ADDENDUM TO THE CONTRACT
for the
D&H STREETS RECONSTRUCTION

Contract No. BE18-247

ADDENDUM NO.: ONE

DATE ADDENDUM ISSUED: May 4, 2018

SHEET NUMBER
14A
OF
22

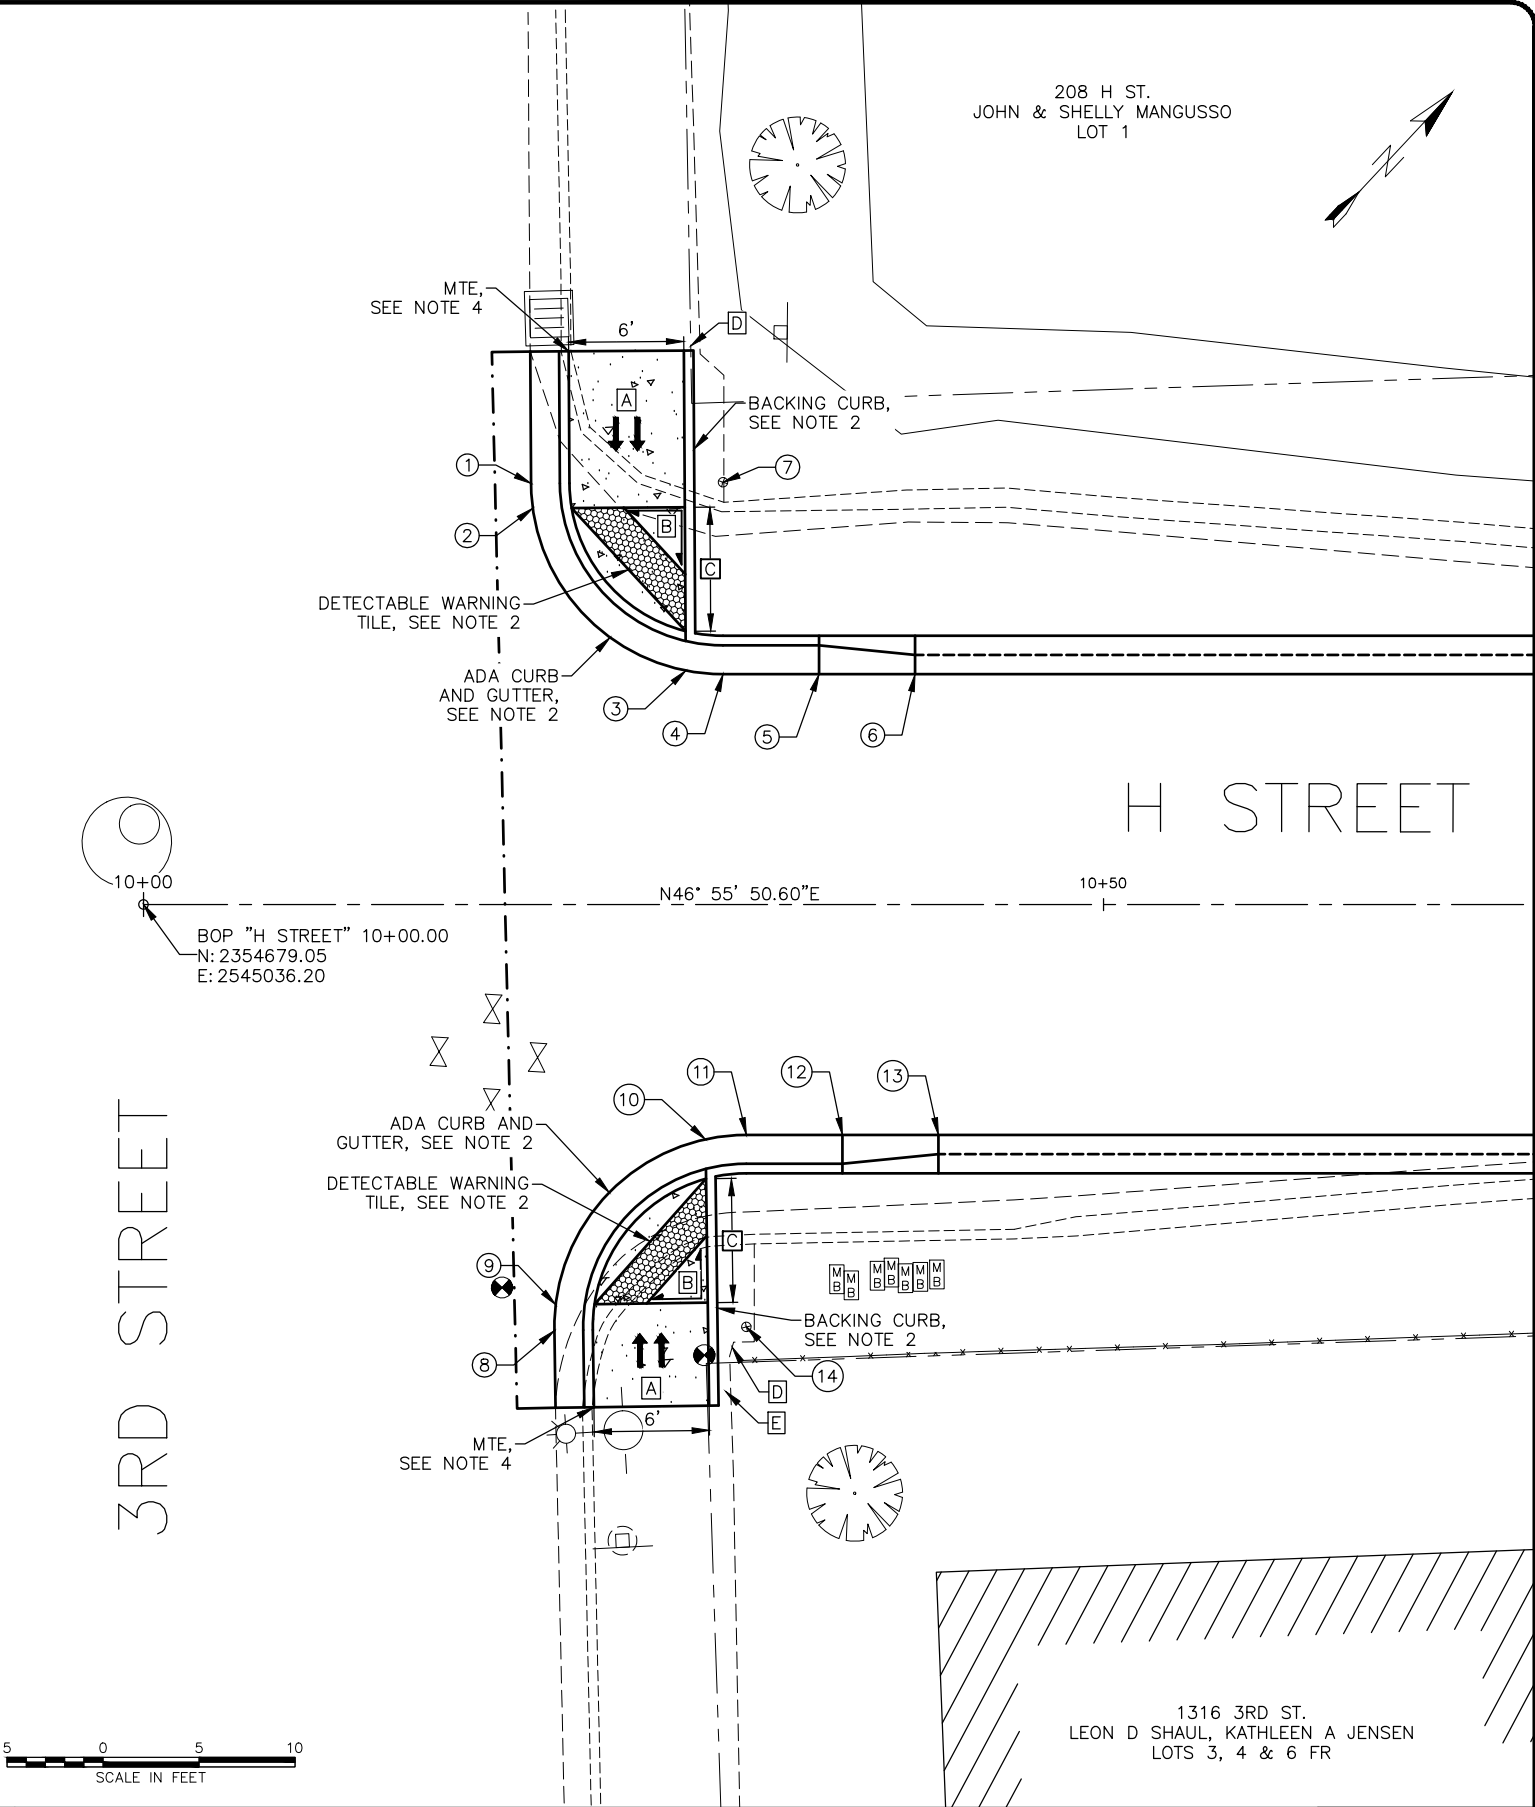
Item No. 3. **Replace** Drawing 14 H & 3RD STREET INTERSECTION, **with** attached Drawing 14A H& 3RD STREET INTERSECTION, labeled ADDENDUM NO. 1.

RECORD OF REVISIONS			
No.	DATE	DESCRIPTION	BY
1	04/18/2018	MODIFIED ADA RAMP LAYOUT. REPLACE ENTIRE SHEET.	LC

- A CONSTRUCT RAMP SLOPES AT 7.70% NOMINAL GRADE, OR FLATTER. RAMP SLOPES MAY BE INCREASED TO A MAXIMUM 8.33% WHEN SITE CONDITIONS WARRANT IT. RAMP LENGTHS SHOULD BE INCREASED TO KEEP GRADES UNDER THE 8.33% MAXIMUM, BUT ARE NOT REQUIRED TO EXCEED 15.0'. THE RESULTING RAMP GRADE AT A 15.0' LENGTH IS ACCEPTABLE EVEN IF IT EXCEEDS 8.33%.
- B LANDING AREA - 4'x4' MIN. DIMENSIONS AND MAX 2.00% SLOPE IN ALL DIRECTIONS. GRADE TO DRAIN TOWARD GUTTER FLOW LINE.
- C IF THE DISTANCE FROM THE BACK OF CURB TO THE BOTTOM OF RAMP RUN GRADE BREAK IS LESS THAN 5' DETECTABLE WARNING TILE SHALL BE PLACE ON THE RAMP RUN.
- D SAWCUT AND REMOVE EXISTING SIDEWALK AS NECESSARY TO PROVIDE A SMOOTH TRANSITION TO PROPOSED CURB RAMP.
- E PRESERVE AND PROTECT EXISTING RETAINING WALL AND HANDRAIL.

SHEET NUMBER	
15A	OF
22

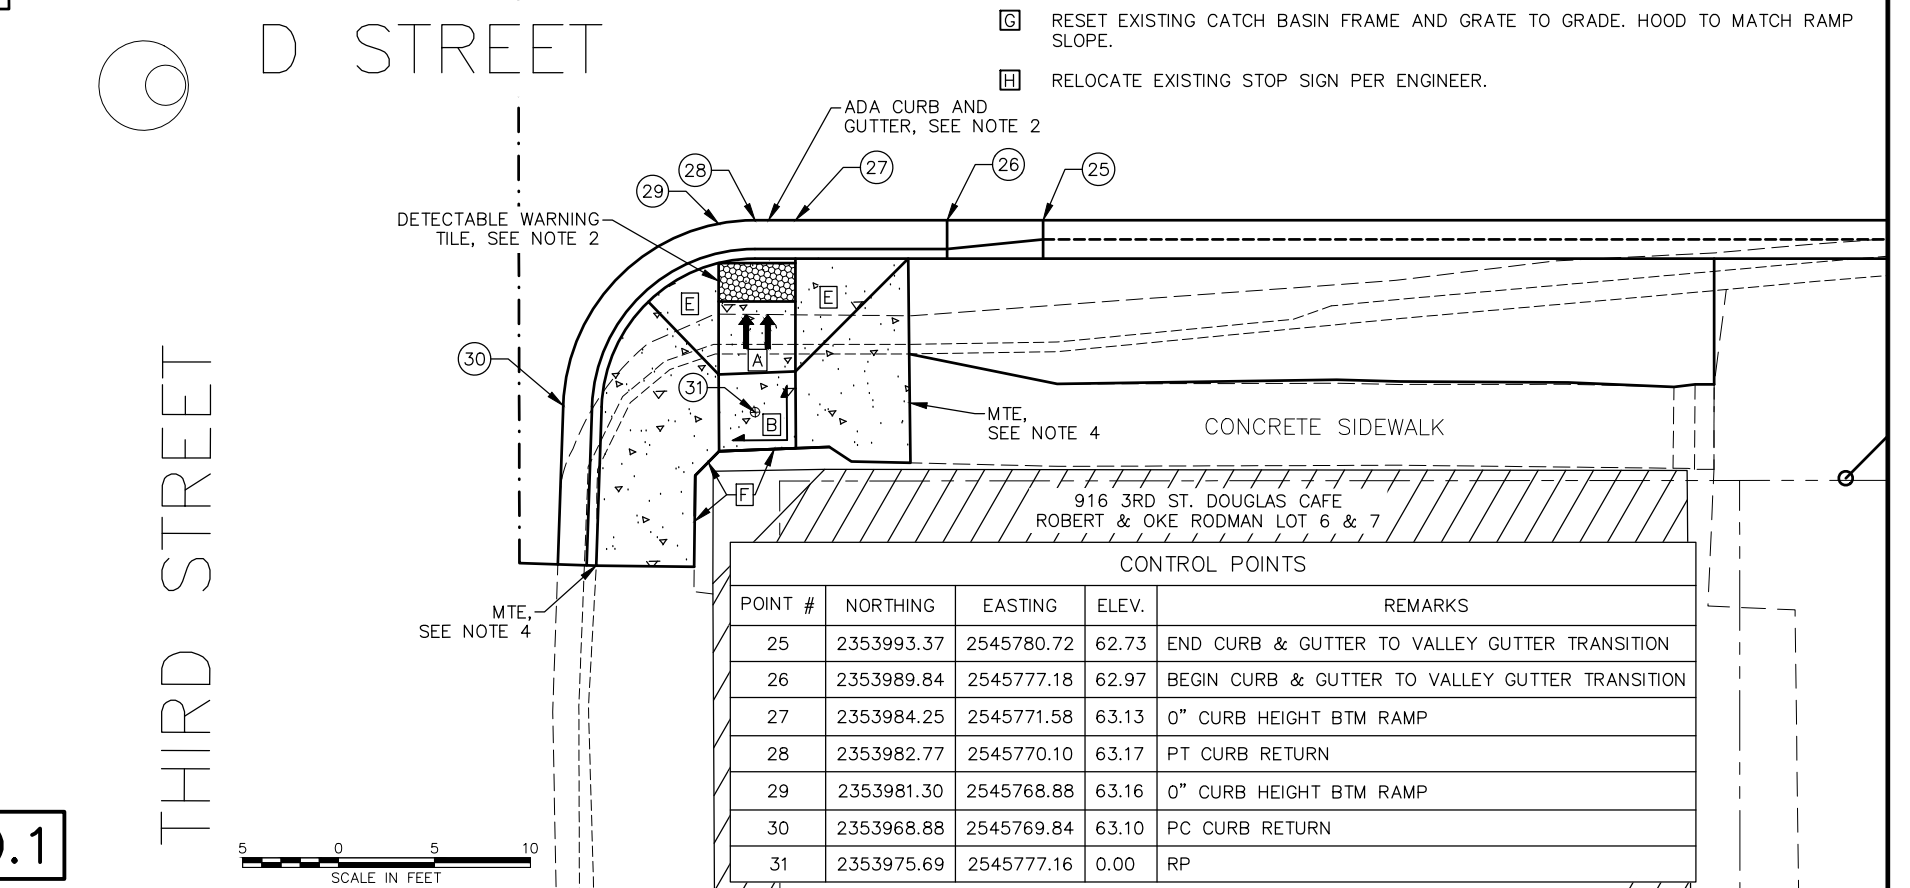
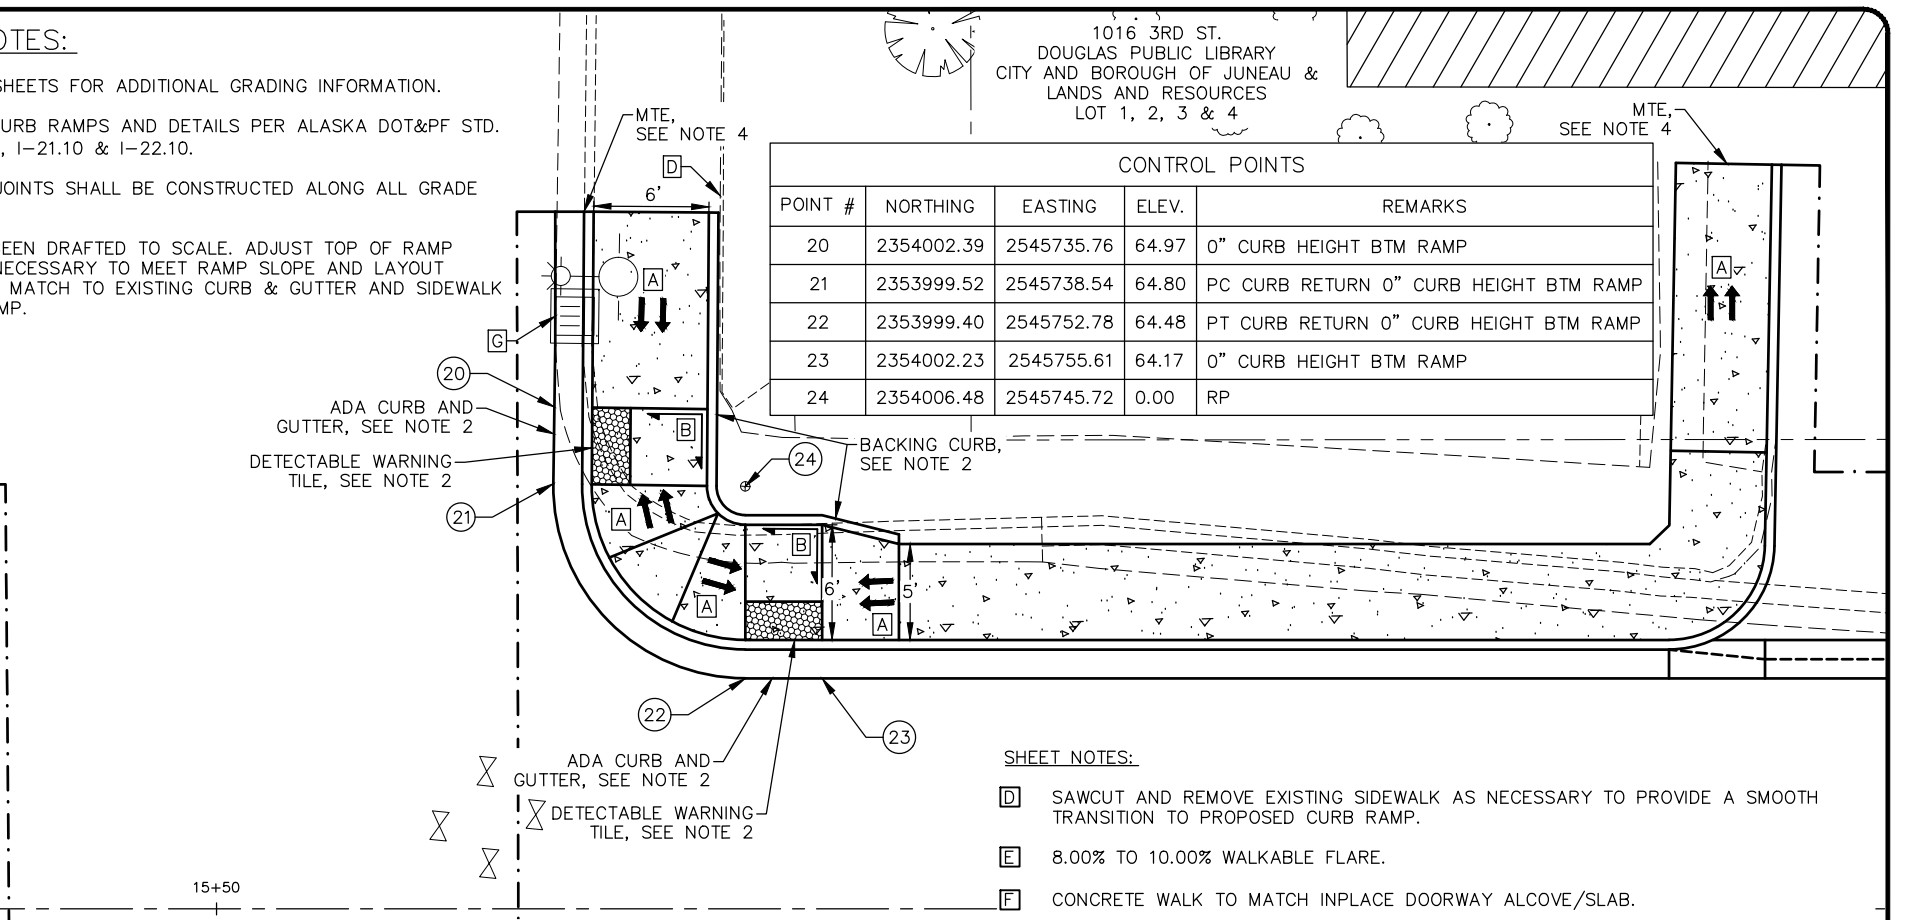
Item No. 4 **Replace** Drawing 15 D & 3RD STREET INTERSECTION, **with** attached Drawing 15A D & 3RD STREET INTERSECTION, labeled ADDENDUM NO. 1.

RECORD OF REVISIONS			
No.	DATE	DESCRIPTION	BY
1	04/18/2018	MODIFIED ADA RAMP LAYOUT. REPLACE ENTIRE SHEET.	LC

- [D] SAWCUT AND REMOVE EXISTING SIDEWALK AS NECESSARY TO PROVIDE A SMOOTH TRANSITION TO PROPOSED CURB RAMP.
- [E] 8.00% TO 10.00% WALKABLE FLARE.
- [F] CONCRETE WALK TO MATCH INPLACE DOORWAY ALCOVE/SLAB.
- [G] RESET EXISTING CATCH BASIN FRAME AND GRATE TO GRADE. HOOD TO MATCH RAMP SLOPE.
- [H] RELOCATE EXISTING STOP SIGN PER ENGINEER.
